KAC Fashion Wear Ltd (Extension)

14th September and 11th October 2021

Observations

Foundation stressed above normal design limit

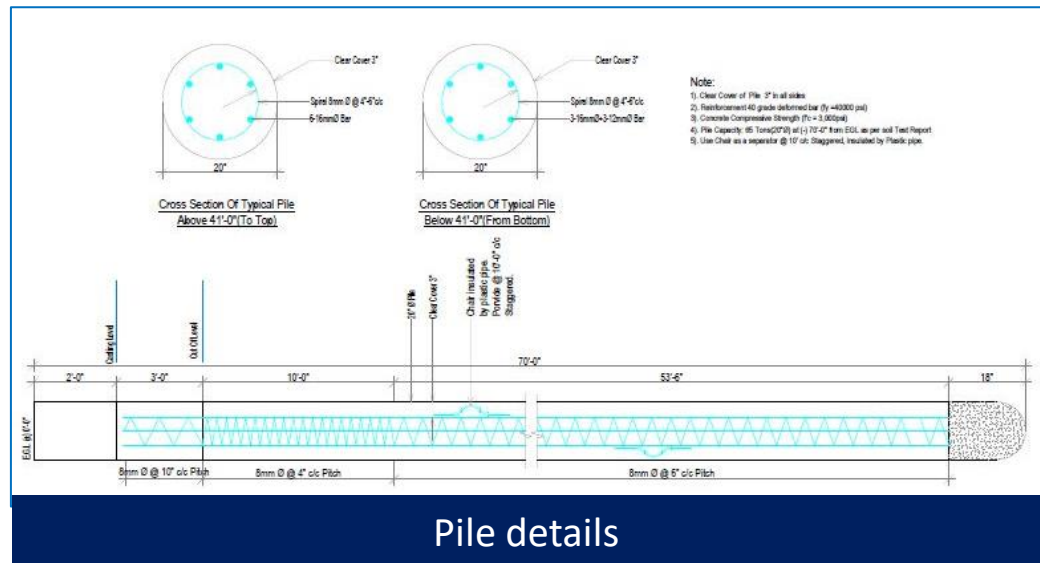
Cursory calculation indicates that bearing capacity of pile exceeds the normal design limit under dining area, considering 3 kPa live load on typical floors. Factory Engineer to review design, loads and foundation stresses.

Discrepancies in as-built drawing

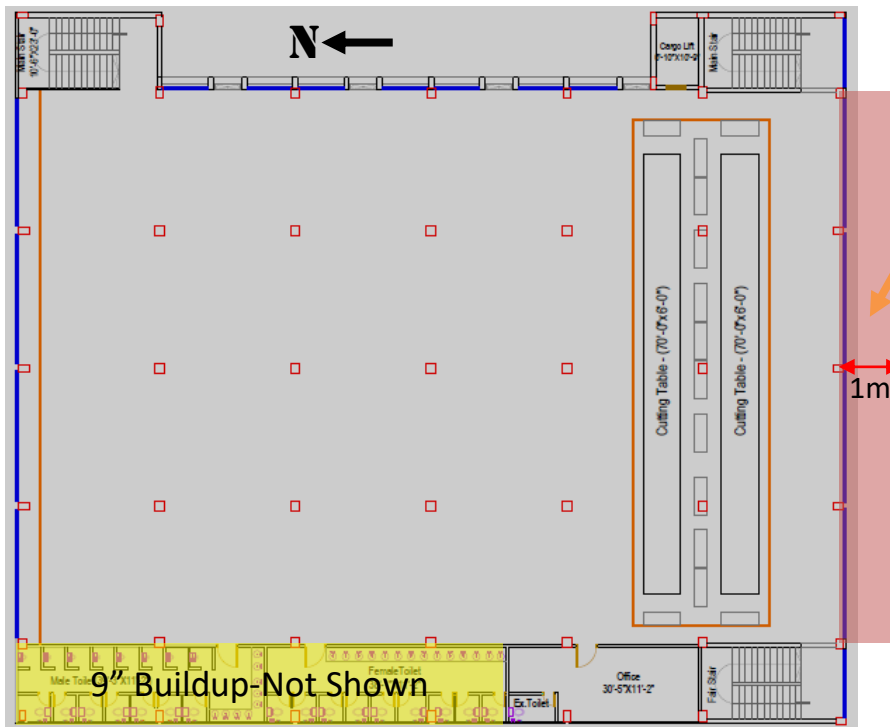
OHWT (not shown in drawing)

Dining shed (not shown in drawing)

Southside cantilever portion at 3rd floor (not shown in drawing)

3rd floor layout plan

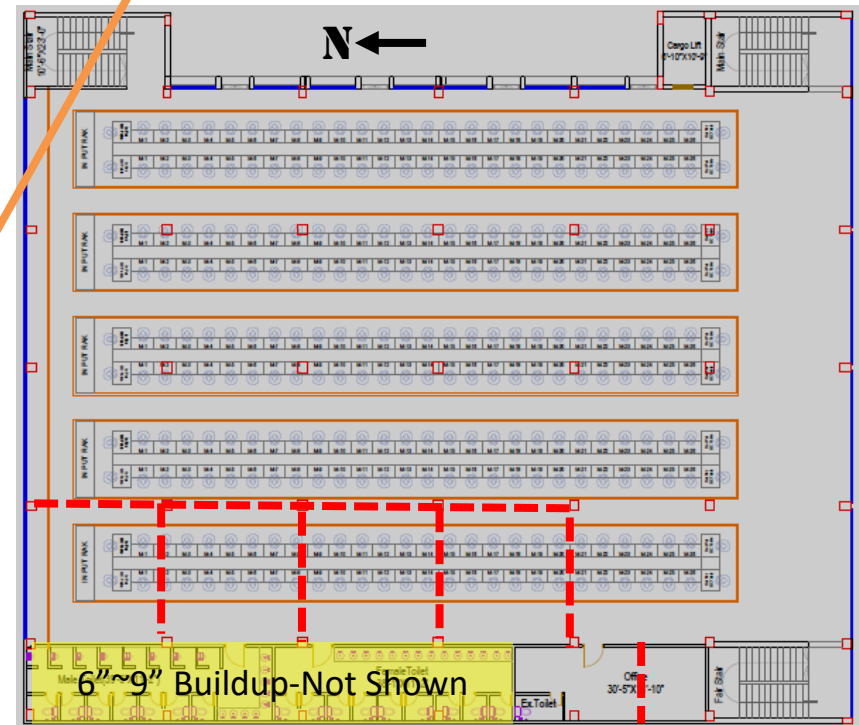
Buildup

125 mm brick wall

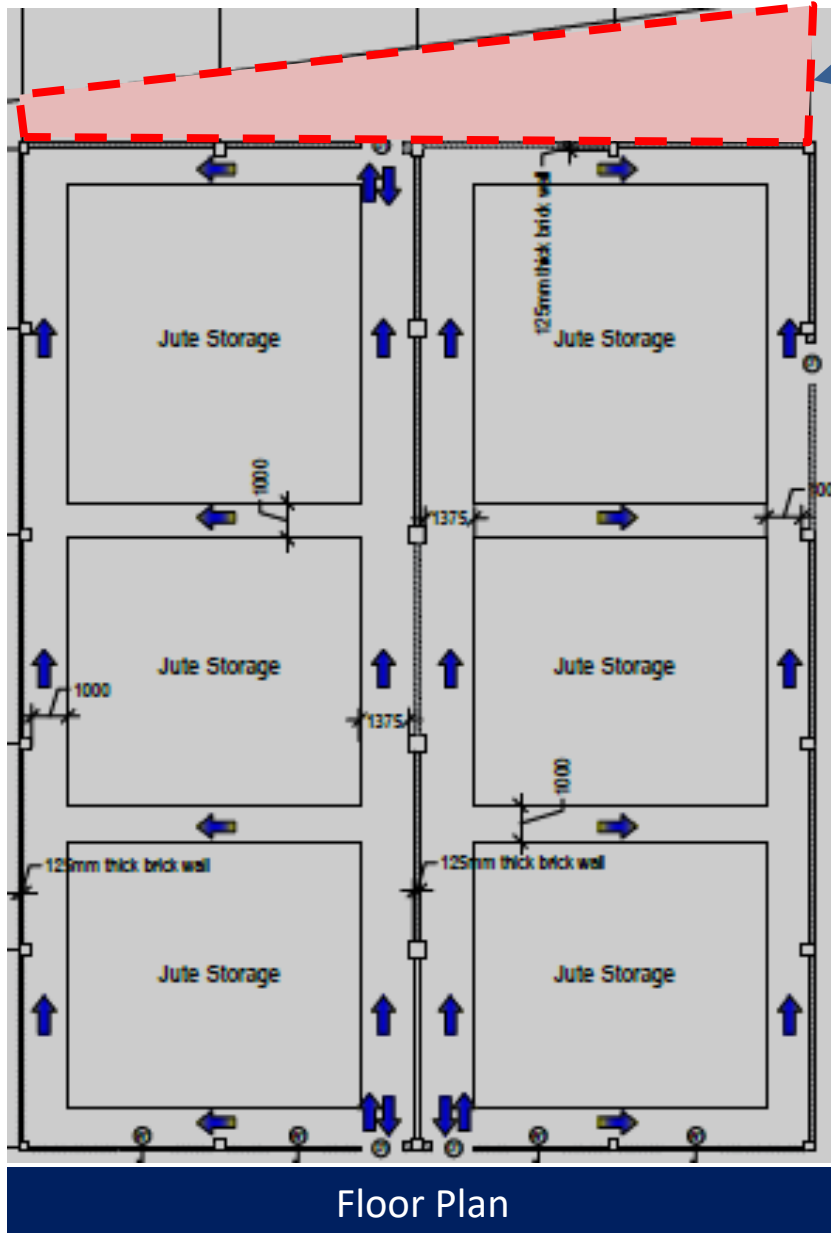
Lack of lateral stability system

No roof bracing and lateral load transfer media

Factory engineer is required to check the stability system and suggest proper actions accordingly.

Inconsistency in as-built drawing

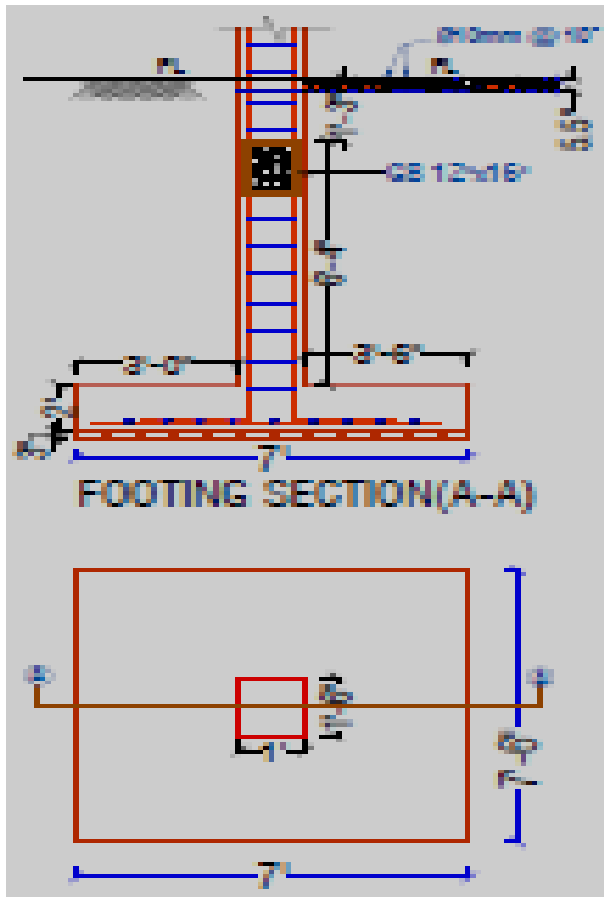
Undocumented extension

No gusset plate at joint between top & vertical chord

Factory Engineer is required to survey the structure and prepare accurate as-built (architectural and structural) drawings.

Footing Layout Plan

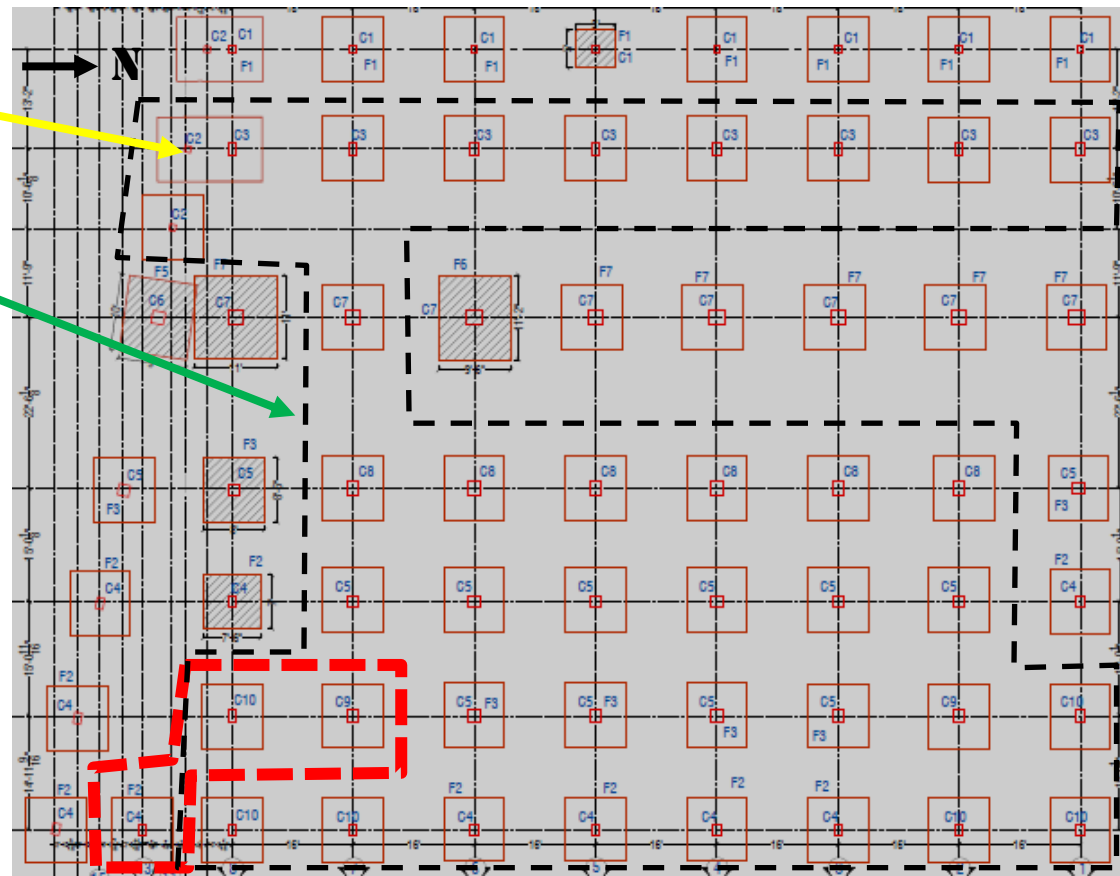
No details of combined footing was found in drawing.

Footing type not mentioned in layout

Footing rebar not mentioned

Cursory calculation indicates that red marked footings are stressed above normal design limit considering observed live load (2 kPa), minimum concrete strength (14.1 MPa) based on aggregate type and ultimate soil bearing capacity 6.88 ksf (330 kPa). Factory engineer is required to review design, load & footing stresses of the building and suggest remedial actions accordingly.

Column Layout Plan

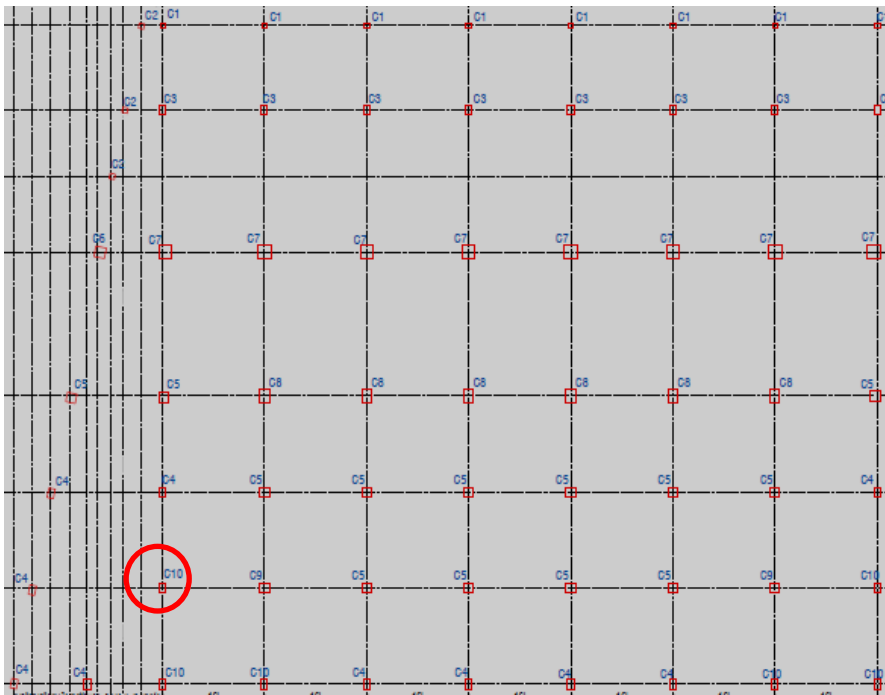
Cursory calculation indicates that columns are stressed above normal design limit considering observed 2 kPa live load and minimum concrete strength (14.1 MPa) based on aggregate type. Factory engineer is required to review design, load & column stresses of the building.

1st floor layout plan

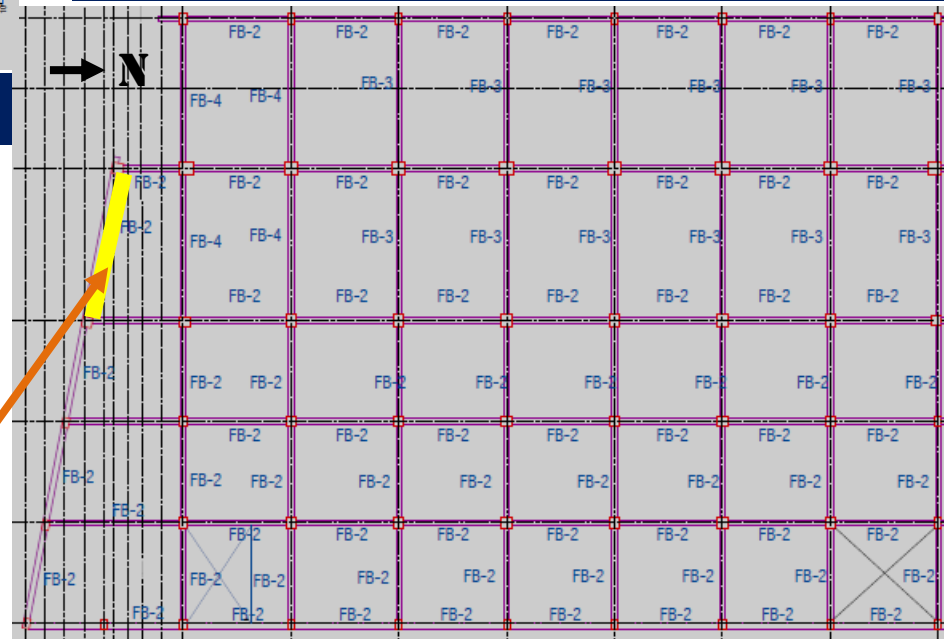
Toilet with 275 mm buildup-not shown in drawing

Beam size –
250mm X 425mm (d/s)
instead of
250mm X 350mm (d/s)

150~275 mm Buildup at each floor toilet area

Non-engineered shed at 1st floor

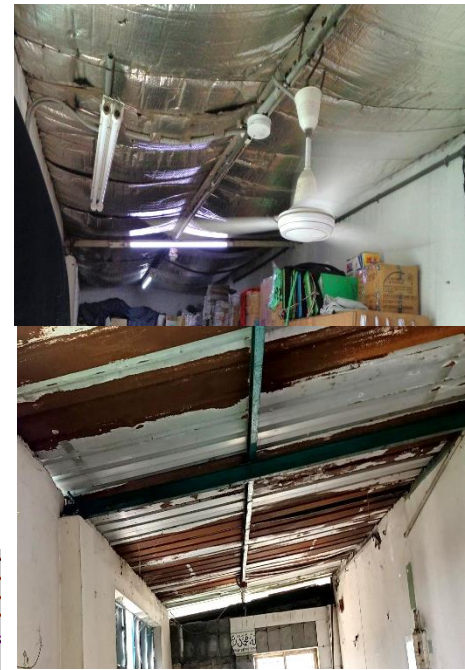
Roof sheet worn out

Factory engineer is required to check the member adequacy of the shed for both gravity and lateral forces or replace the shed by an engineering structure.
